1968 Corvette: Service Bulletin: Heat Damage to Engine Wiring Harness

Subject: Heat Damage to Engine Wiring Harness

Bulletin No: 68-T-25

Date: Feb. 19, 1968

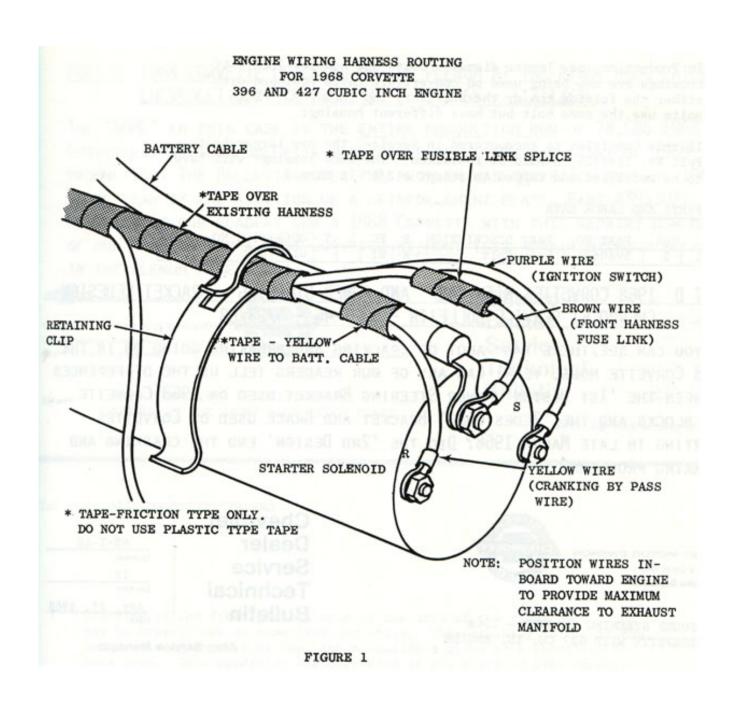
The engine wiring harness on some early production 1968 passenger vehicles equipped with either the 396 or 427 cubic inch engine may be subject to exhaust manifold heat damage harness wires are not properly routed through the retaining clip located on the starter solenoid. Reports have indicated that the yellow colored ignition or cranking by-pass wire, which attaches to the solenoid terminal closest to the exhaust manifold, is the wire most often damaged by exhaust manifold heat. To prevent damage, the wire must be routed "loop-free" through the solenoid retaining clip to the solenoid terminal.

Effective November 27, 1967, the assembly plant is repositioning and taping the wiring harness on all Corvettes with either the 396 or 427 cubic inch engine as shown in figure 1. Proper routing of the engine wiring harness through the retaining clip on all other passenger vehicles with the 396 or 427 engine is being more closely maintained at all assembly plants.

If heat damage to the engine wiring harness is encountered on subject 1968 Corvette models in the field, the harness should be taped as shown in figure 1. If harness replacement is necessary, the new harness should be similarly taped at the time of installation. All other 396 or 427 cubic inch engine passenger cars require only proper wire routing to avoid heat damage from the manifold. This wiring should be checked for proper routing at the time of new car preparation.
